IMPORTANT RETROFIT NOTICE

INFORMATION BULLETIN NO. 67

TO: ALL OWNERS, OPERATORS, AND REBUILDERS OF J. H. FLETCHER & CO. RRII/DDO ROOF BOLTING EQUIPMENT

SUBJ: RETROFIT—PRESSURE SETTING ON RRII/DDO

DRAWING 18-97-7/A

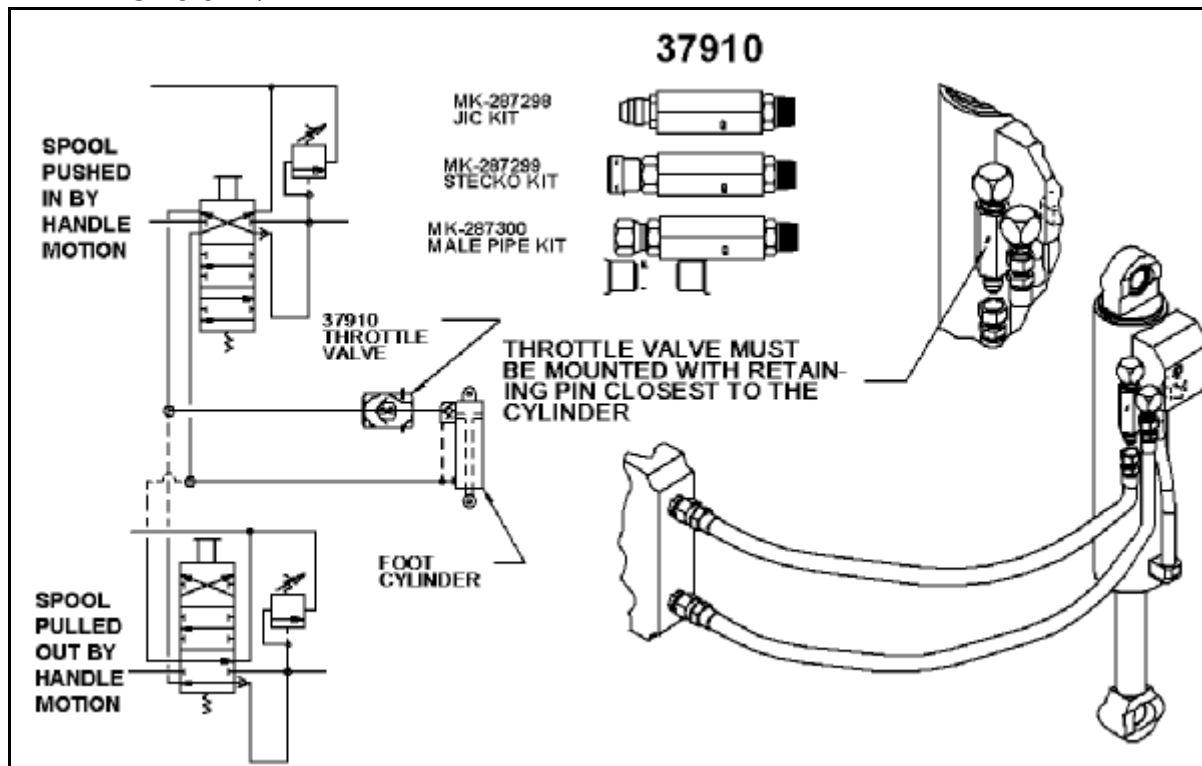
It is imperative to maintain the specified pressure in the foot jack circuit. Since we are now aware of instances where this is not being done, we will provide an orificed check valve kit to be installed into the foot jack circuit. This will prevent the rapid dropping of the drill canopy if the foot jack is capable of raising the boom structure, but it will not prevent the mechanical interaction between the drill booms.

4. The orificed check valve to be installed in each **DDO/RRII** foot jack circuit will be provided by Fletcher free of charge (see drawing 18-97-7/A for RRII or drawing 20-97-10/A for DDO).
